Temporary Windshield Fogging After Blower Start-Up – Install Revised Control Module

MODEL 1995 MY  
Sedan Range  
VIN  
720001 - 741196

ILLUSTRATION 1

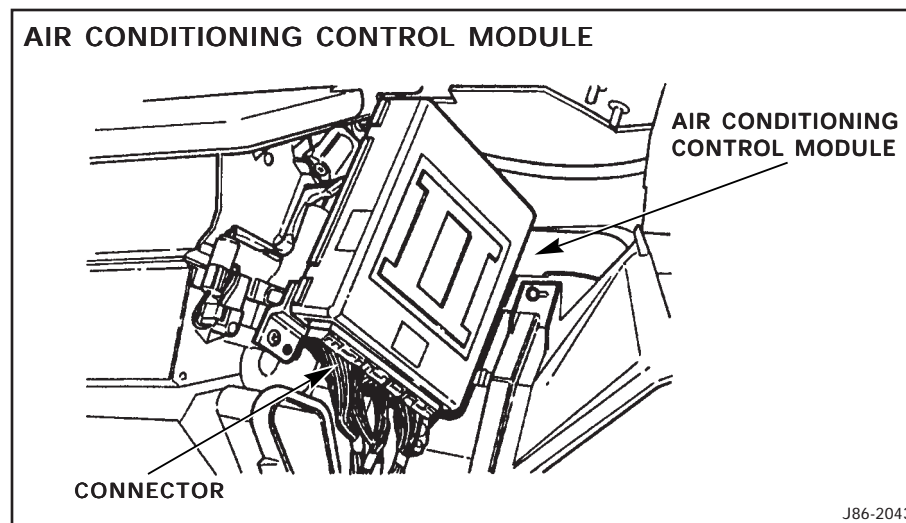
1. Disconnect battery negative cable.
2. Remove the right side dash liner and the right side footwell outlet duct.
3. Disconnect the A/CCM harness connectors (Illustration 1).
4. After removing the screws, remove the A/CCM (Illustration 1).

5. Position the new A/CCM so the mounting brackets engage correctly in the locating pegs and install.
6. Connect the connectors.
7. Align and install the footwell air duct.
8. Install the dash liner.
9. Connect the battery negative cable and reset the clock.
